POLICY REPORT
DEVELOPMENT AND BUILDING

TO: Vancouver City Council
FROM: General Manager of Planning and Development Services
SUBJECT: CD-1 Rezoning - 755-795 West 41st Avenue

This report evaluates an application to rezone five lots located at 755-795 West 41st Avenue from RS-1 (One-Family Dwelling) District to CD-1 (Comprehensive Development) District, to permit the development of two six-storey residential buildings and two-storey townhouses containing 74 dwelling units all over two levels of underground parking. Staff have assessed the application and find that it meets the intent of the Cambie Corridor Plan. Staff support the application, subject to rezoning conditions outlined in Appendix B. Staff recommend that the application be referred to a Public Hearing, with the recommendation of the General Manager of Planning and Development Services to approve it, subject to the Public Hearing along with the conditions of approval outlined in Appendix B.

Building Code Review

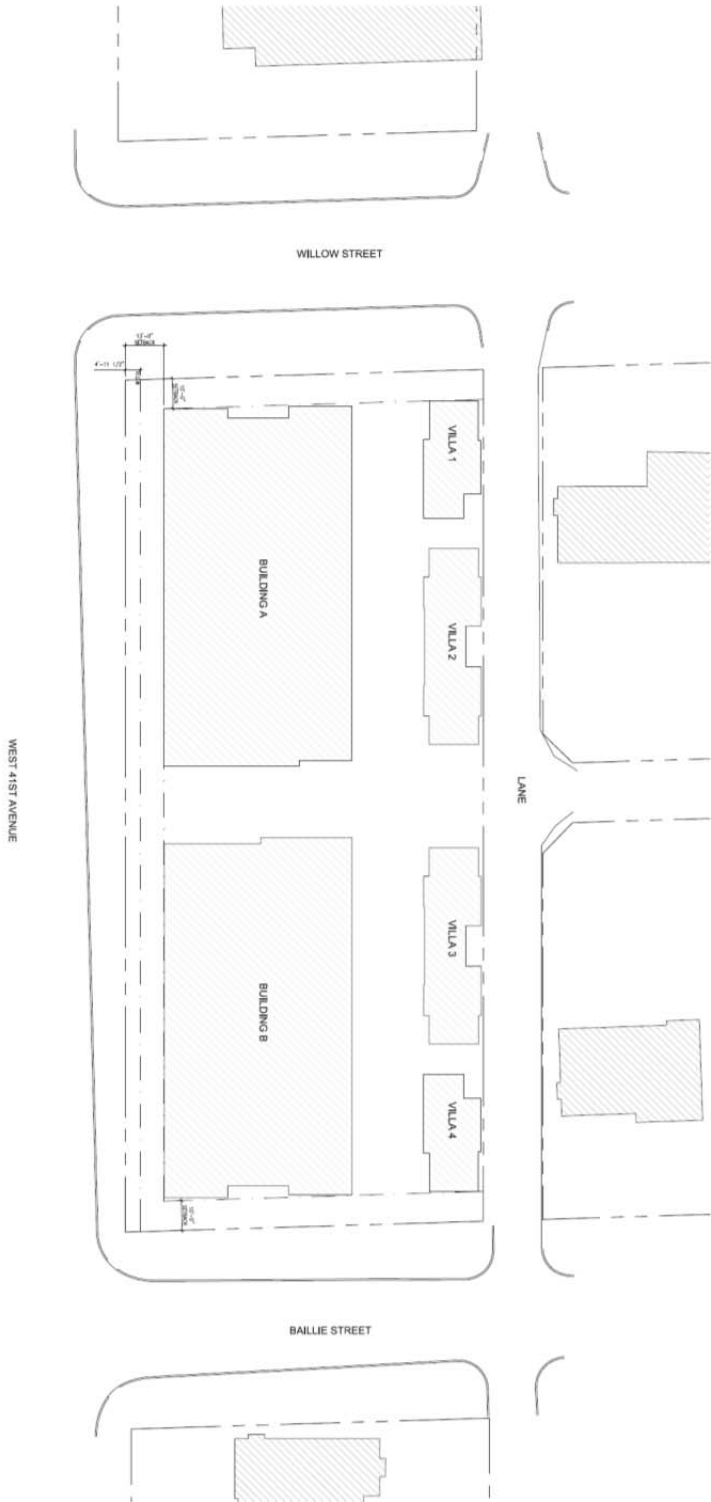
As a general note: this project consists of a single building over a common underground storage garage. There are 2 towers (3.2.6 requirements for high buildings does not apply) separated by a central breezeway, and, low-rise townhouses at the North of the site.

1. Exits at the 2 towers are non-conforming. A minimum of 2 exits per floor are required within both of the 2 towers however the plans only show 1 potential exit at ground level via an exit lobby in both towers, albeit with residential suites opening directly onto these lobbies in contravention of Clause 3.4.4.2.(2).(c) of the Building By-law. At the exit stairwells in both towers there is no indication of where the second proposed exit stair leads to (i.e. 1 leads to an exit lobby, the 2nd stair does not exit at ground level). This means that floor levels 2 through 6 in both towers are only served by 1 exit (2 are required).

2. The plans do not clearly show the means of egress/exits from the storage garage. The stairs do not lead to the towers' ground floor exit lobbies, they appear to discharge at the breezeway but the plans do not show a connection between the stairs at the breezeway and the exit stairwells in the storage garage. A minimum of 2 exits must be provided from the storage garage beneath the towers. Other issues noted are: convergence of exits at the breezeway is not permitted if these are the only 2 exits from the parking garage, and, at the West tower the door that opens onto the ground floor public corridor from the upper landing of the proposed exit stairwell of the storage garage obstructs the width of the means of egress (public corridor) in contravention of Sentence 3.3.1.23.(1) of the Building By-law.
